INTRODUCTION

Duke Energy Indiana, LLC (“Duke Energy Indiana” or the “Company”) submitted its 2024 integrated resource plan (“IRP”) to the Indiana Utility Regulatory Commission (“Commission” or “IURC”) on November 1, 2024. The Company appreciates stakeholders’ thoughtful and constructive comments on its 2024 IRP and the continuation of the collaborative process through which the IRP was developed. The Company seeks to continuously improve its planning processes, including engagement with interested stakeholders, and will consider these comments in the development of its next IRP in 2027. In addition, Duke Energy Indiana would like to take this opportunity to provide clarification on particular topics to the Commission and explain areas of respectful disagreement with certain positions put forward in stakeholder comments. The fact that some items are not addressed in these reply comments should not be taken, necessarily, as agreement with stakeholders on those topics.

OSB Stakeholder Feedback

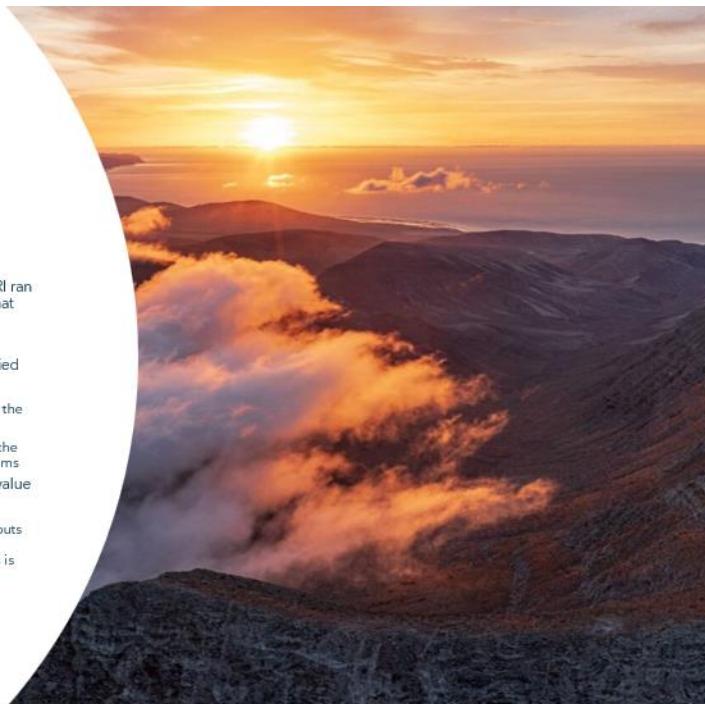
- Modeled EE Tax Credits as being additive with DEI program incentives
- Program administrative costs should be revised downwards → RI ran an additional scenario for economic and achievable potential that uses lower program administrative costs

- Calibrate the Low Income Weatherization Program to recent program achievements → RI modeled all existing income-qualified programs under the name "Low Income Neighborhood"

- Low Income Weatherization has been modeled exclusively as the IRA HOMES program scenario
 - Allows DEI to identify income-qualified retrofit impacts from the IRA funding as distinct from existing income-qualified programs

- Update measure inputs to use a larger average square footage value of single family homes
 - RI cannot accommodate this request, as it affects measure inputs that were established early in the study, existing values are reasonable estimates and the impact from proposed changes is minimal in comparison to the overall level of potential in the study

Additionally, as previously noted, part of the delay cited by Joint Commenters resulted directly from efforts to incorporate stakeholder feedback. The following slide is from the IRP stakeholder session on June 3, 2024:

Figure 2: Solar and Battery Storage Costs (\$/kW) – 2028 Projects

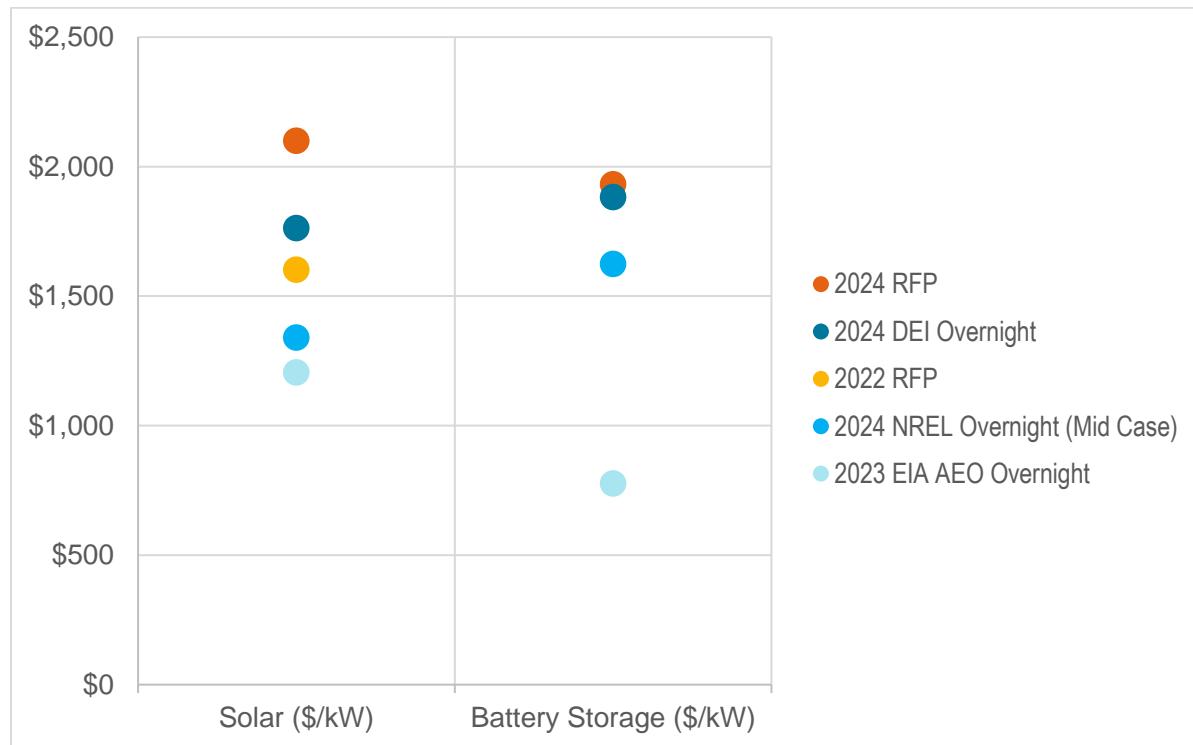
Sierra Club, AEU, and CGA opined that the 2024 IRP capital cost forecasts for renewable energy and battery energy storage resources were too high, citing publications that report lower costs.

Sierra Club highlighted capital costs from the 2024 NREL ATB,²⁸ commenting that the capital costs for solar modeled by the Company are "considerably higher" than those projected by NREL. Similarly, AEU referenced EIA, suggesting that "large-scale non-fossil and energy supply resources may be overestimated by several hundred dollars per kilowatt" when compared to EIA's Assumptions to the Annual energy Outlook ("AEO") 2023: Electricity Market Module.²⁹ However, the 2024 ATB is based on data from the first quarter of 2023, the most recent available historical data at the time the report was prepared. NREL itself noted "Cost fluctuations that may occur between each set of years are not represented, such as the fluctuations because of policy and market conditions that occurred after the first quarter of 2023."³⁰ The EIA's 2023 AEO is based on even older information. During periods of rapid change and volatility such as the industry is currently experiencing, considerable changes can occur even as a report is being developed. The Company addressed this challenge in the 2024 IRP by benchmarking cost estimates against bid data from the 2024 RFP.

Figure 2, below, presents capital cost projections for solar and battery energy storage projects to be placed in service in 2028. The graph compares the overnight costs used by the Company in the 2024 IRP to overnight costs from NREL's 2024 ATB and EIA's 2023 AEO³¹ (shades of blue). The graph also provides average bid prices from the Company's 2022³² and 2024³³ resource solicitations (shades of orange). While the overnight costs may not be directly comparable to RFP bids, which

may or may not include some amount of expected financing cost, two observations are clear. First, the average bid cost in the 2024 RFP is higher than all overnight cost projections, including the Company's. Second, the cost of solar, for which acquisition costs are available for both the 2022 and 2024 RFPs, has increased considerably in recent years. For these reasons, the Company is confident that the capital cost forecasts it used in the 2024 IRP are the most reasonable.

Figure 3: Solar and Wind (\$/MWh) and Battery Storage (\$/kW-year) PPA – 2028 Projects

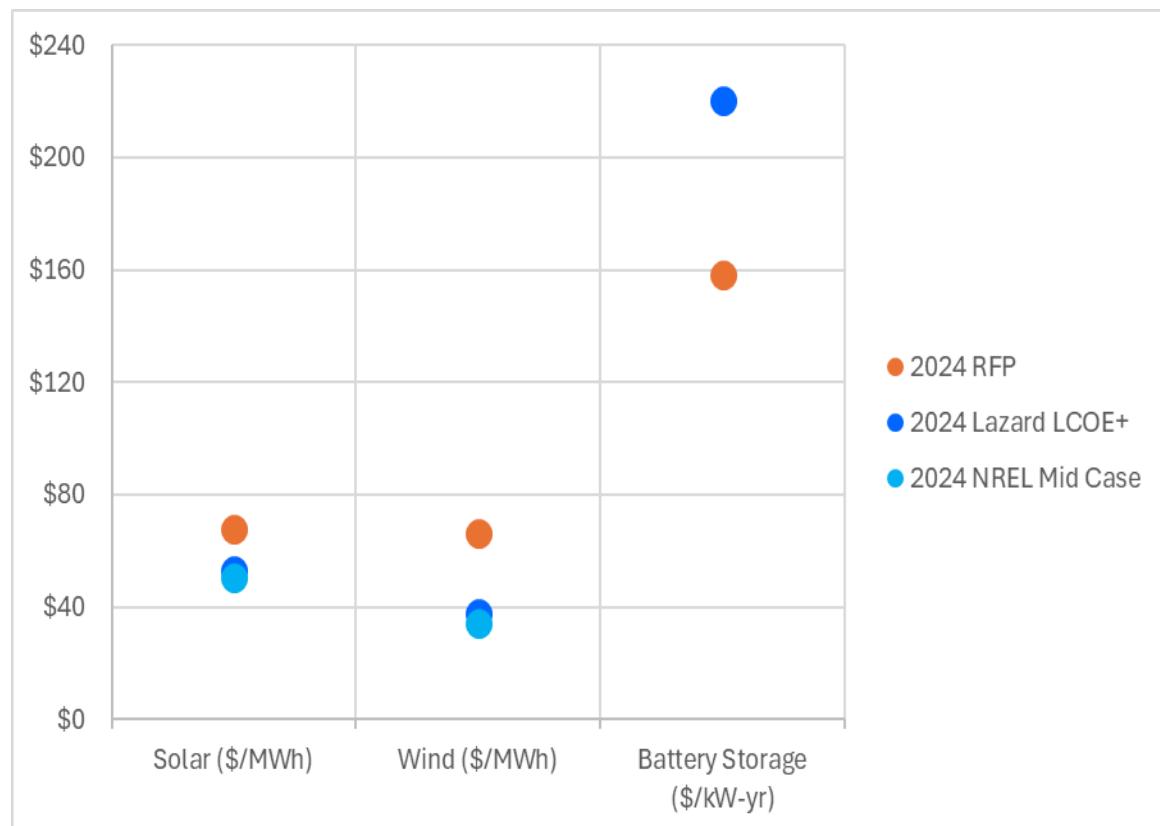
In addition to Sierra Club's and AEU's comments on resource capital cost assumptions, CGA suggested that the Duke Energy Indiana should have used LCOE to compare resource costs, contending that "the overall cost-competitiveness of wind, solar, and storage is not reflected in the 2024 IRP, in which only overnight capital costs by technology type are compared."³⁴ Fortunately, CGA's concerns are unfounded. The 2024 IRP is based on thorough and robust capacity expansion and production cost analysis which incorporates resource capital costs, operating costs, fuel costs, and a wide range of other factors explained in Chapter 2, Chapter 3, and Appendix C of the 2024 IRP document. While LCOE may be "a widely recognized economic measure,"³⁵ it is an energy-only metric that fails to account for other essential factors crucial to resource selection, most importantly time-of-use and capacity value. LCOE is a useful tool for rough comparison of projects *within* a given resource type, but is not appropriate for comparison *across* resource types with different reliability and operating characteristics. CGA suggests that adding "firming" costs to the LCOE resolves this issue, but this is no substitute for full resource planning analytics of the kind supporting the 2024 IRP. It is also worth noting that, although the LCOE estimates referenced by CGA find that renewables

are “competitive with natural gas”³⁶ even after accounting for firming costs, the resource that provides that firm capacity is assumed to be a natural gas turbine.³⁷ This underscores the essential role of dispatchable generation in supporting system reliability as market penetration of variable energy and energy-limited resources increases.

Limitations of the LCOE metric notwithstanding, Duke Energy Indiana compared renewable and storage power purchase agreement (“PPA”) bids received in its recent RFPs to LCOE projections from the 2024 NREL ATB and Lazard’s LCOE publication.³⁸ Figure 3, below, presents this comparison, clearly illustrating the fact that costs of projects actually available to Duke Energy Indiana exceed estimates from NREL and Lazard, with the exception of energy storage.
